Second Five-Year Review Report

**For
Homestake Mining Company Superfund Site
Cibola County, New Mexico**

September 2006

FIVE-YEAR REVIEW
Homestake Mining Company Superfund Site
EPA ID# NMD007860935
Cibola County, New Mexico

Figure 15 Uranium Concentrations of the Upper Chinle Aquifer
(Reproduced from Hydro-Engineering 2006)

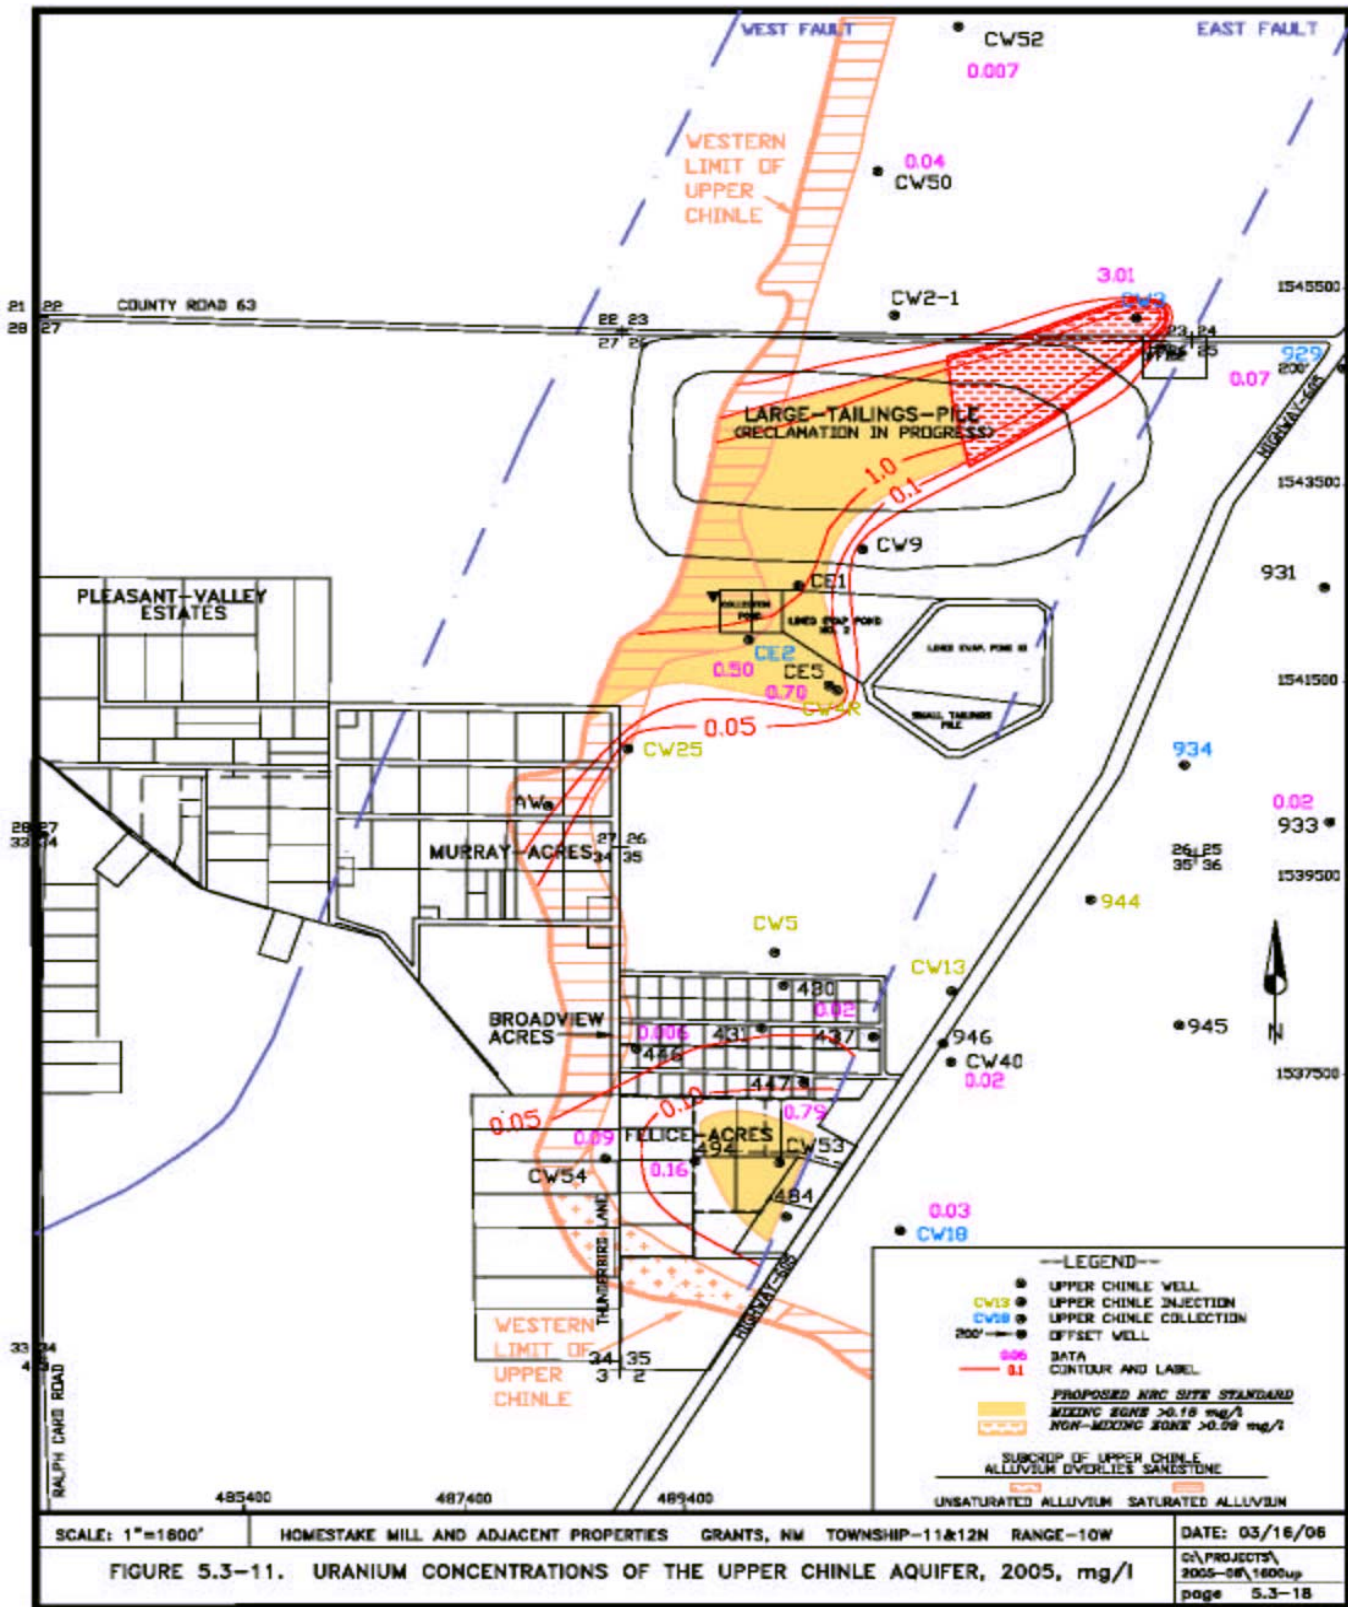
The location of Upper Chinle wells is shown on Figure 15 along with the iso-concentration plots of uranium in the Upper Chinle aquifer. Uranium concentrations in the Upper Chinle aquifer exceed the proposed background concentration of 0.18 mg/l within the mixing zone location at the Large Tailings Impoundment and at the mixing zone location within the Felice Acres subdivision as shown in Figure 15. Uranium concentrations also exceed the proposed background concentration of 0.09 mg/l in the Upper Chinle for several hundreds of feet beyond the mixing zone within the Felice Acres subdivision and between the mixing zone and extraction well CW3 in the vicinity of the Large Tailings Impoundment. An examination of uranium concentration trends provided in the 2005 Annual Report (Hydro-Engineering 2006) for the Upper Chinle show that uranium concentrations are either stable or declining in all wells except well CW-3 as shown in Figure 16. Uranium concentrations have increased substantially in this well because this well has been pumped as a source of flushing water through the mixing zone at the Large Tailings Impoundment. Selenium concentrations in the Upper Chinle aquifer have exceeded the mixing zone background concentration of 0.14 mg/l at well CW54 located within the Felice Acres subdivision. Selenium also exceeded the non-mixing zone background of 0.06 mg/l at extraction well CW3 located adjacent to the Large Tailings Impoundment.

Figure 17 Water Level Elevation of the Middle Chinle Aquifer
(Reproduced from Hydro-Engineering 2006)

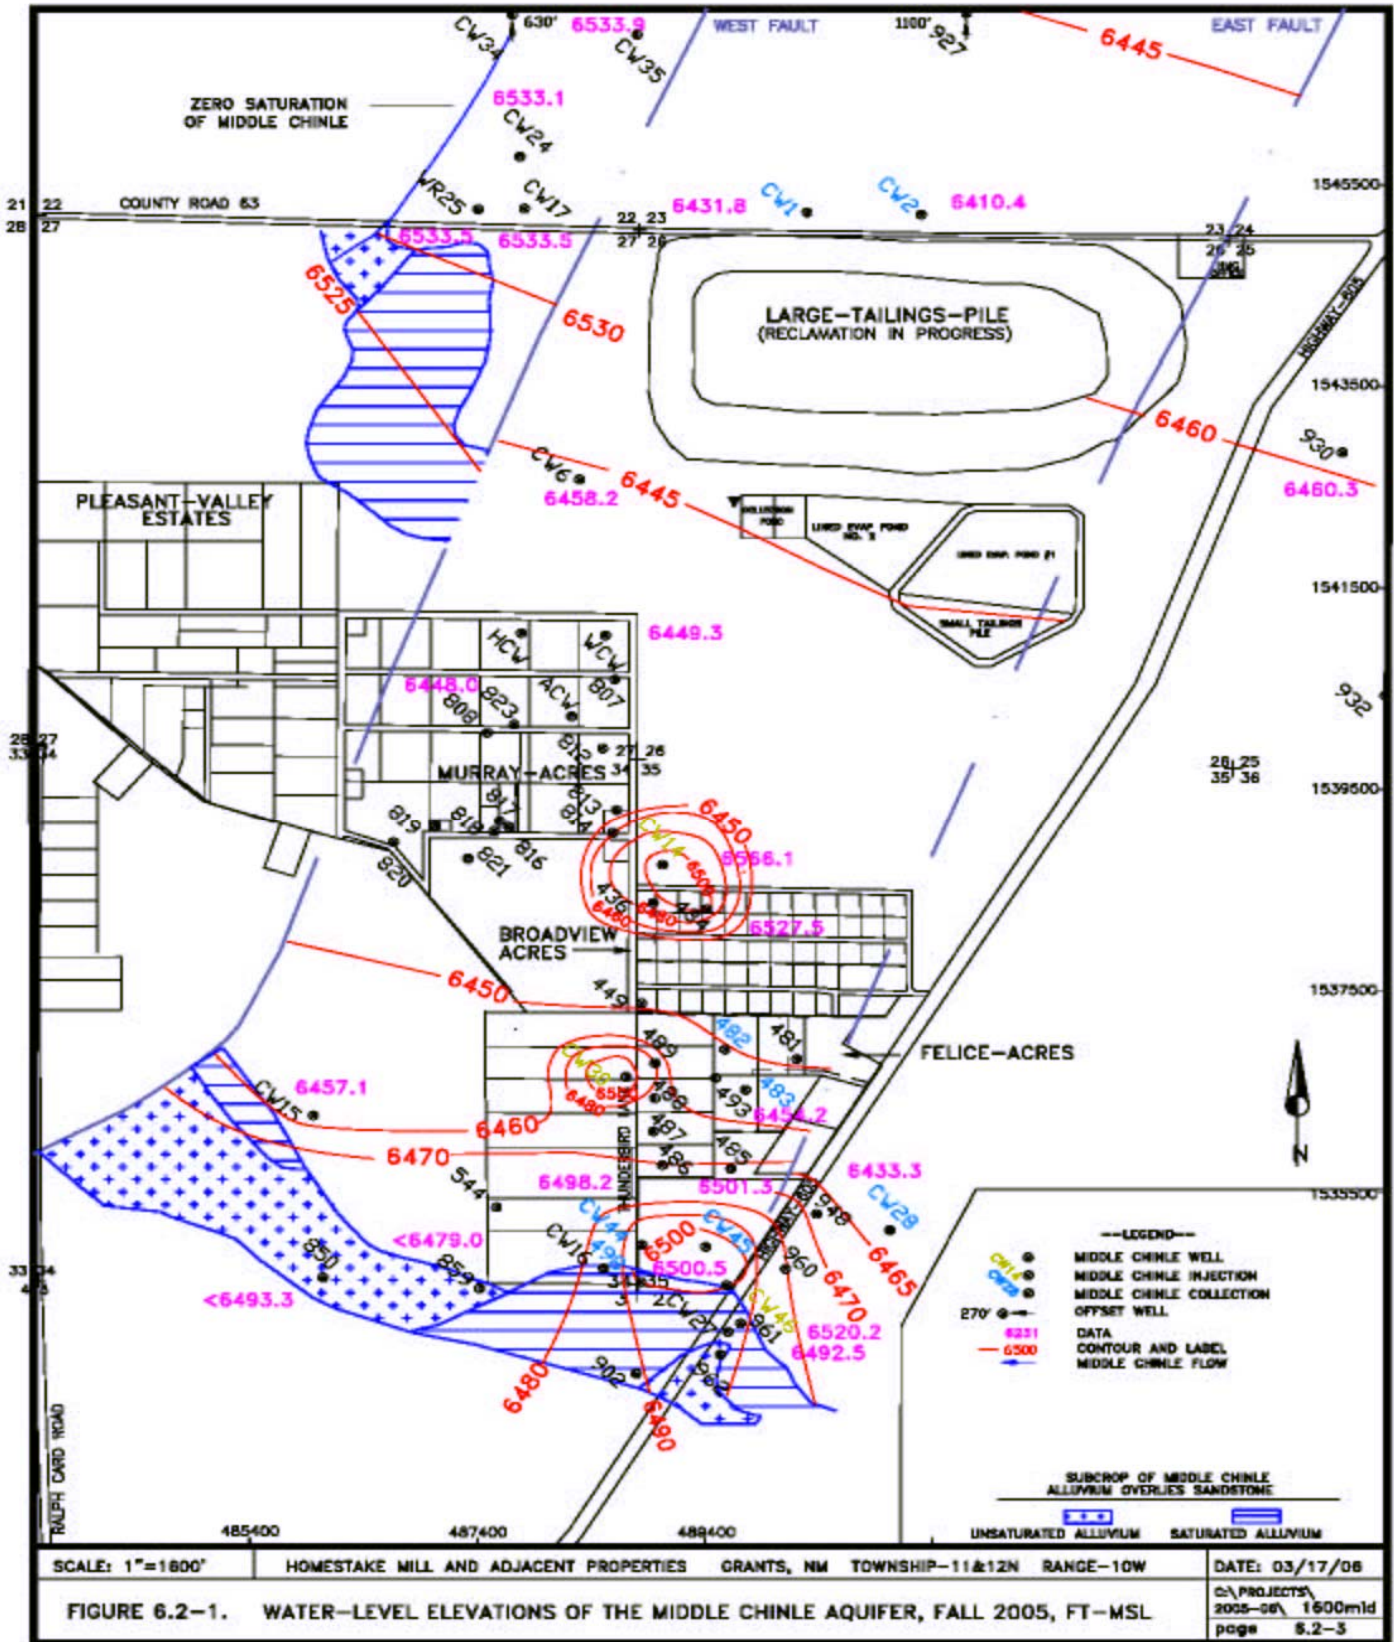
Middle Chinle Aquifer. Figure 17 shows the Middle Chinle wells and water level measurements and water level contours of the Middle Chinle aquifer for the Fall of 2005. This figure shows the positions of the East Fault and West Fault and locations where the Middle Chinle aquifer exists and where the Middle Chinle aquifer subcrops beneath both saturated and unsaturated alluvium. There is significant displacement across the West Fault. The limited portion of the Middle Chinle aquifer that exists west of the West Fault functions as two separate ground water systems, with different water levels and flow directions. West of the fault the flow is toward the alluvial subcrop. East of the West Fault, the hydraulic gradient in the Middle Chinle aquifer is generally in a northeast direction toward the collection wells, except for localized mounding near injection Wells CW14, CW30 and CW46.

Figure 18 Uranium Concentrations of the Middle Chinle Aquifer
(Reproduced from Hydro-Engineering 2006)

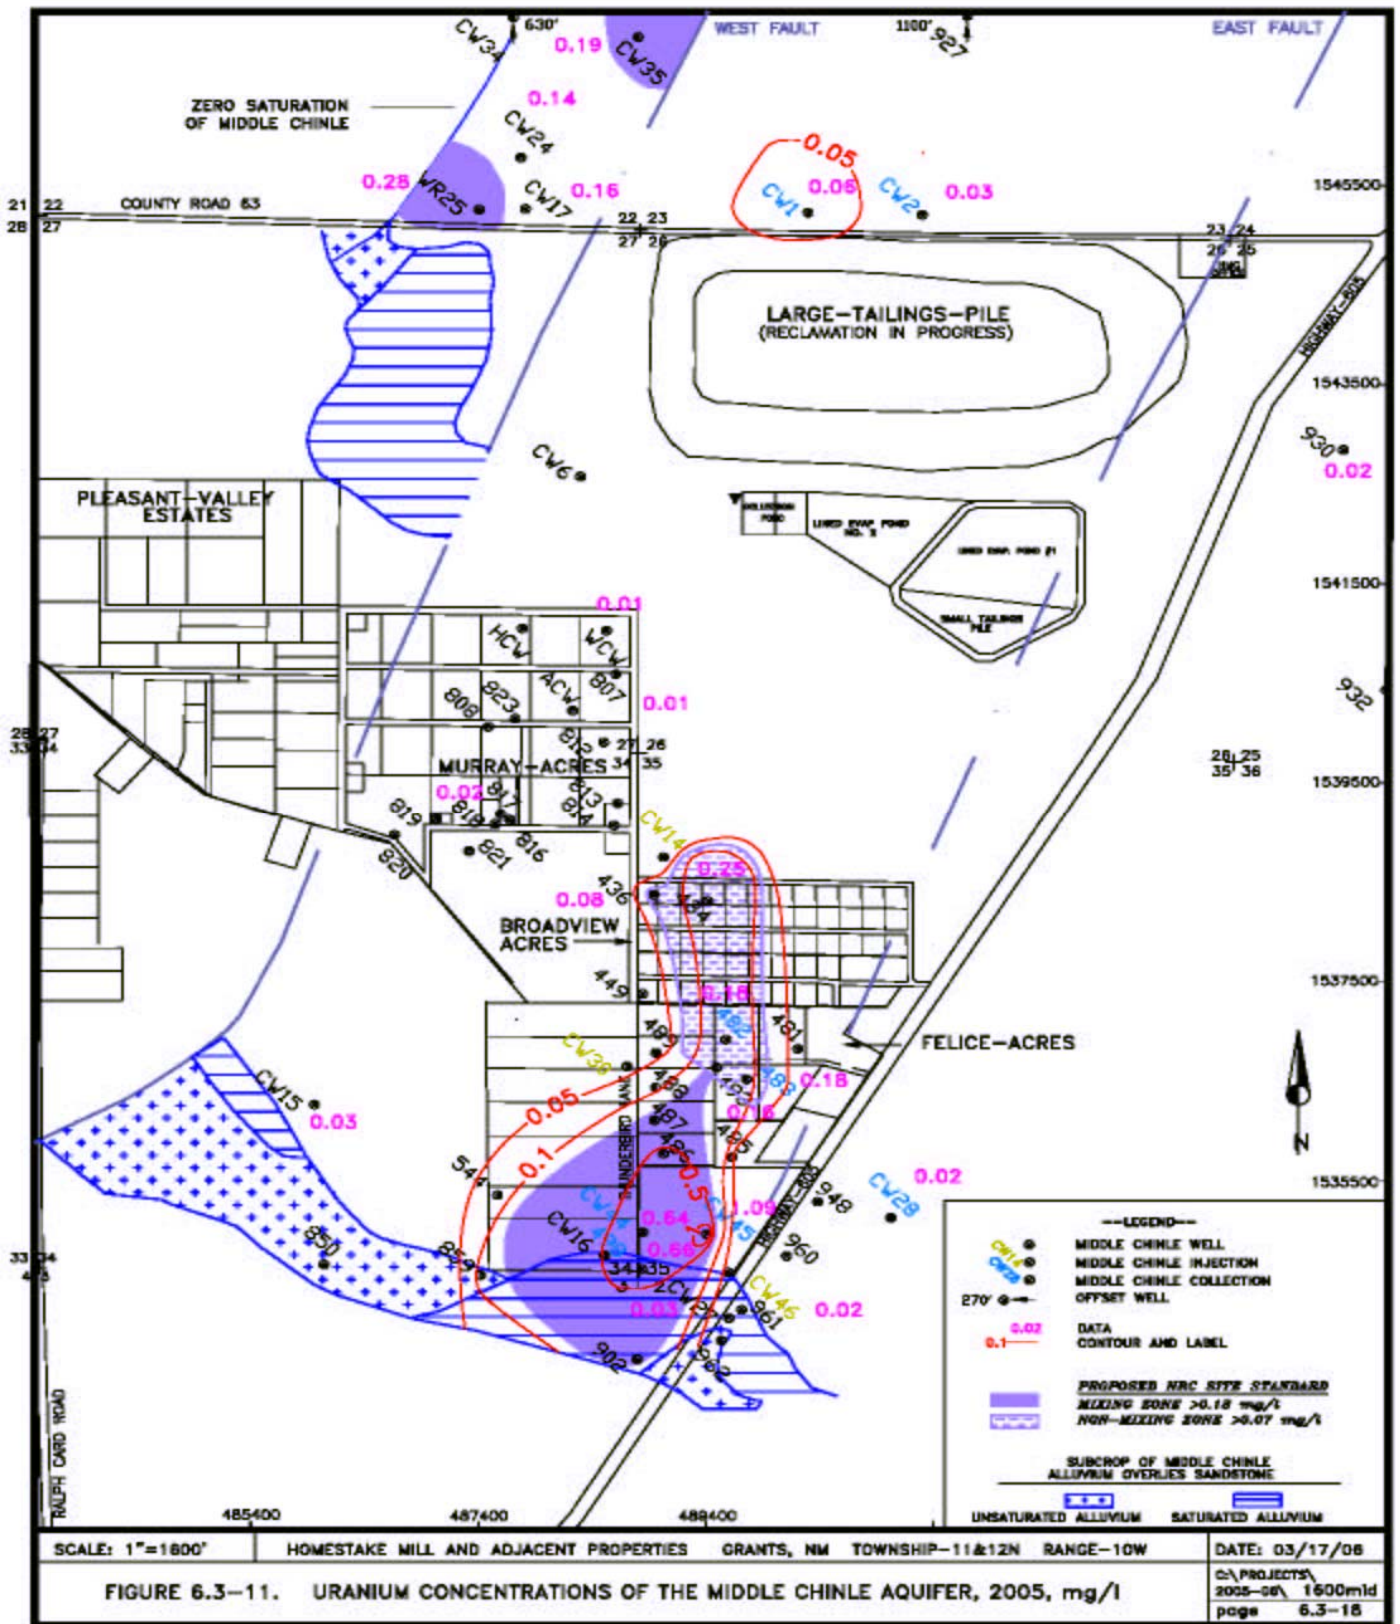
Figure 18 provides isoconcentration plots of uranium in the Middle Chinle aquifer during 2005. The map also depicts the boundaries of the aquifer, including where it subcrops beneath the overlying San Mateo alluvium deposits. The map shows one area within the Middle Chinle and two areas within the mixing zone of the Middle Chinle aquifer, where the uranium concentrations in 2005 were above the corresponding background concentrations. The uranium concentrations in the mixing zone located

Figure 21 Water Level Elevations of the Lower Chinle Aquifer (Reproduced from Hydro-Engineering 2006)

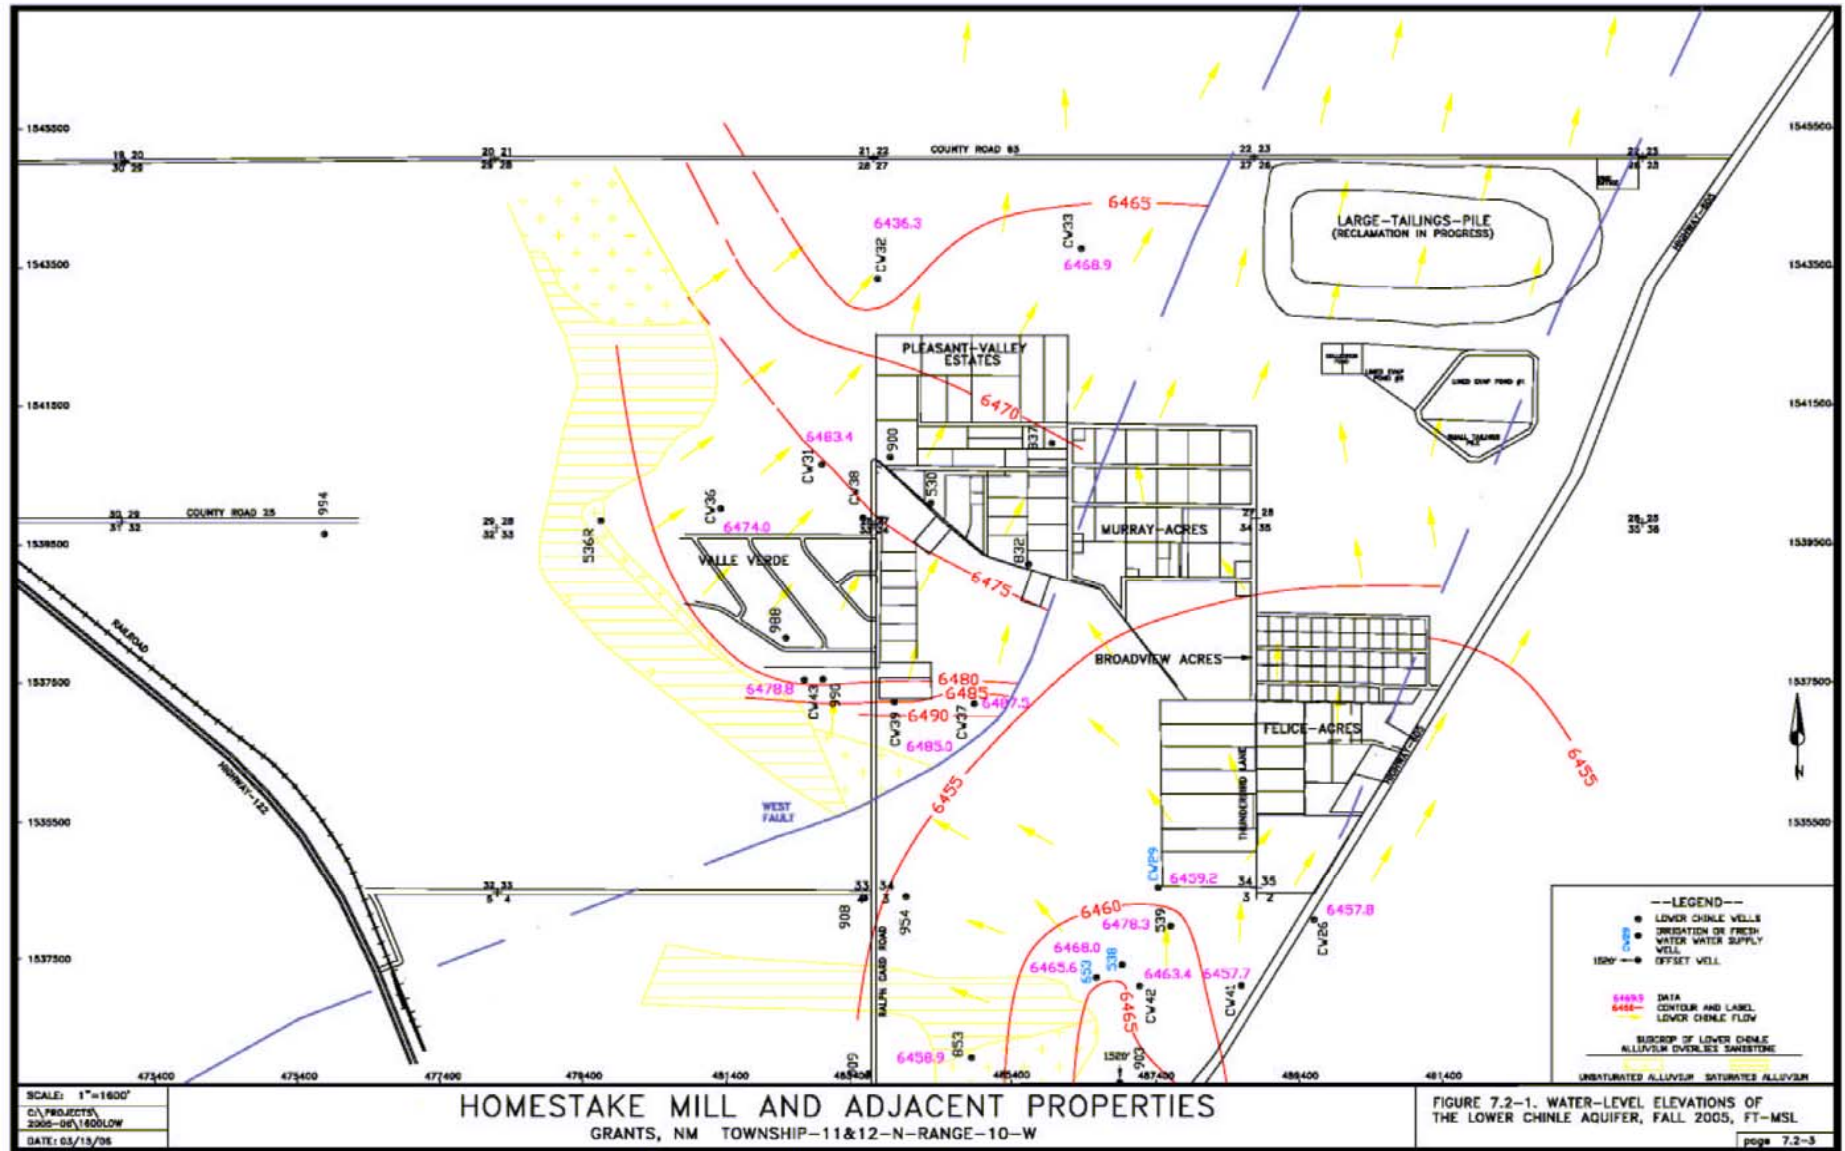
Lower Chinle Aquifer. Figure 21 shows the Lower Chinle wells and water level measurements and water level contours for the Fall of 2005. This figure shows the positions of the East Fault and West Fault and locations where the Lower Chinle aquifer exists and where the aquifer subcrops beneath both saturated and unsaturated alluvium. Flow west of the West Fault in the Lower Chinle is from the subcrop area toward the northeast. The flow in the Lower Chinle between the two faults is in a north and northwest direction from the subcrop area toward the West Fault. This potentiometric surface indicates preferential flow along a more permeable zone adjacent to the West fault because water levels are higher west of the West Fault. Lower water-level elevations occur in the Lower Chinle around irrigation supply well CW29 due to pumping from this well during the irrigation season.
